RESUBMITTAL 10-13-86:

RESUBMITTAL 9-9-87:

GRADING & DRAINAGE PLAN
BALLOON FIELD INDUSTRIAL PARK
LOTS 11, 12 & 13

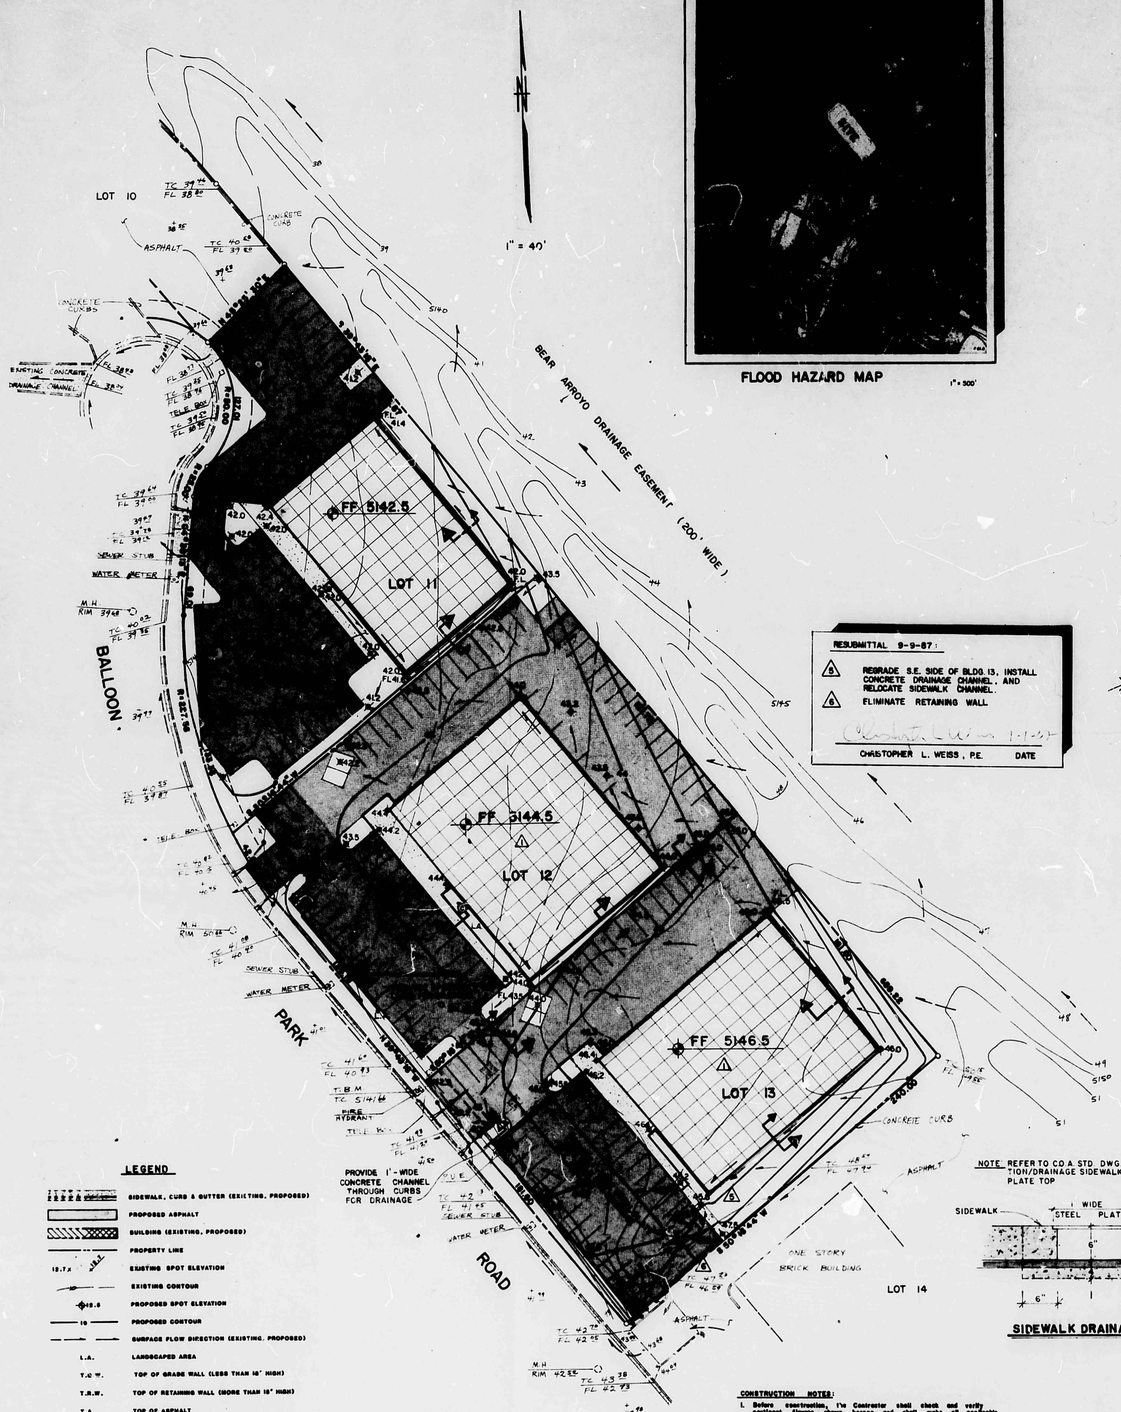
1. LENGTHEN BUILDINGS 12 & 13 BY 5' EACH
2. REVISE HEADER CURB, SECTION C
3. REPLACE CONCRETE CHANNEL WITH 2-4" PVC PIPES, SECTION A

5. REGRADE S.E. SIDE OF BLDG 13, INSTALL CONCRETE DRAINAGE CHANNEL, AND RELOCATE SIDEWALK CHANNEL.
6. ELIMINATE RETAINING WALL

1. MOVE BUILDINGS, LOTS 12 & 13, AND REVISE PARKING LOTS, LOTS 11, 12 & 13

1. REVISE PARKING LOTS 11, 12 & 13
2. MOVE REFUSE PAD & ENCLOSURE LOTS 11, 12 & 13
3. PROVIDE STEEL GRATE THRU WALK FOR DRAINAGE, LOT 13
4. CONSTRUCT RETAINING WALL, LOT 13
